W3F1-2010-0049

Subject: Response to Request for Additional Information Associated with  
Technical Specification 3/4.9.7, Crane Travel – Fuel Handling Building  
Waterford Steam Electric Station Unit 3  
Docket No. 50-382  
License No. NPF-38

**Response to Request for Additional Information**

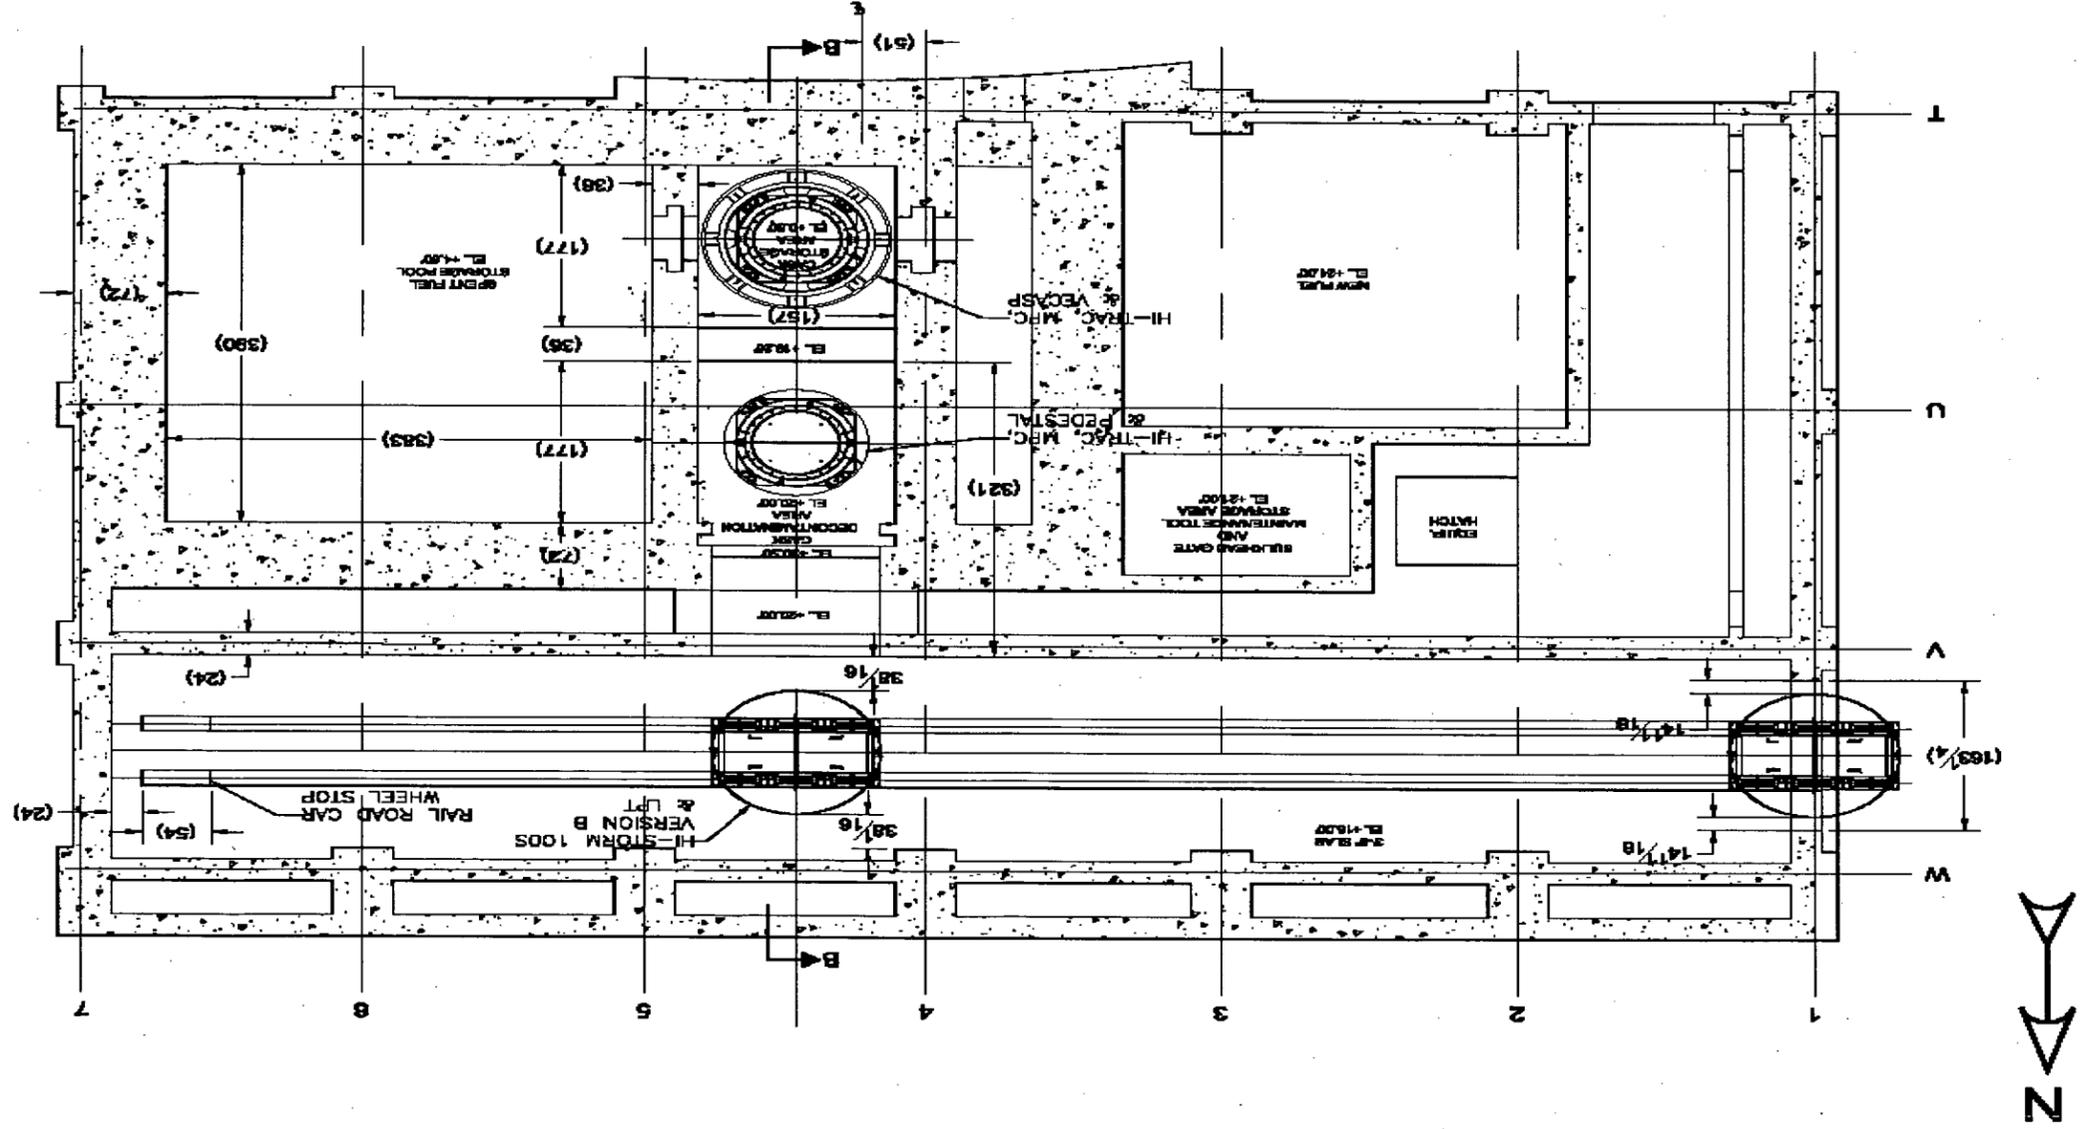
Please provide a simple sketch of the layout showing the arrangements for the Safe Load Path as per NUREG-0612, Control of Heavy Loads at Nuclear Power Plants, July 1980.

The attached sketch shows the layout of the areas where the spent fuel cask will be set down inside the Fuel Handling Building. The cask will be loaded with fuel in the cask storage area. The HI-TRAC and the MPC will then be lifted up to clear the gates in the pool, moved due north, and set down in the cask decontamination area. Once all ancillary activities are completed, the cask will then be lifted up, and moved further north with the cask transfer taking place on top of the low profile transporter in the FHB train bay.

The installation of the HI-TRAC and a new empty MPC will follow the opposite path for installation back in the cask storage area.

The path followed by the HI-TRAC and MPC will be the load path originally defined as the path for a spent fuel cask during the design phase of Waterford 3.

There will be other heavy loads that will be moved, such as the MPC lid, and some ancillary equipment, however, the load paths for this equipment have not yet been defined. Waterford 3 is still defining the proper lay down and storage locations for some of this equipment, which will define the required safe load path.
